MINERALS PROGRAM INSPECTION REPORT PHONE: (303) 866-3567

MINE NAME:	MINE/PROSPECTING ID#:	MINERAL:	COUNTY:
Portland Limestone Quarry	M-1977-344	Limestone (general)	Fremont
INSPECTION TYPE:	INSPECTOR(S):	INSP. DATE:	INSP. TIME:
Monitoring	Timothy A. Cazier	April 26, 2017	12:45
OPERATOR:	OPERATOR REPRESENTATIVE:	TYPE OF OPERATION:	
Holcim (US) Inc.	Nick Bellino	112c - Construction Regular Operation	
DE LONI FOR INGREGATION	BOND GAY GUY ARION RIVER	DOME AMOUNT	
REASON FOR INSPECTION:	BOND CALCULATION TYPE:	BOND AMOUNT:	
Normal I&E Program	Partial Bond	\$5,268,550.00	
DATE OF COMPLAINT:	POST INSP. CONTACTS:	JOINT INSP. AGE	NCY:
NA	None	None

Photo 7. Erosion rilling / gullying observed along Bear Creek realignment (looking NW).

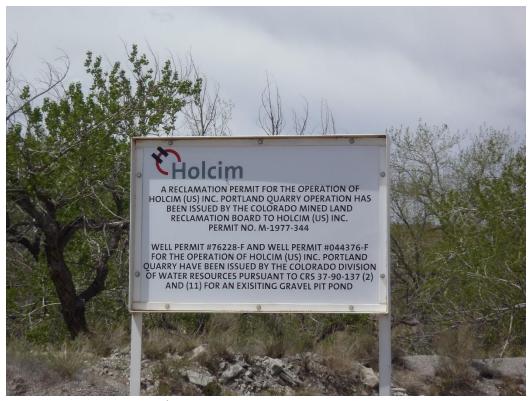
<u>Sediment Control:</u> Some erosion rilling and gullying were observed along the Bear Creek realignment (see **Photos 6** and **7**). The Division recommends implementing best management practices (BMPs) such as straw wattles and/or erosion control blankets to control erosion until the vegetation is established.
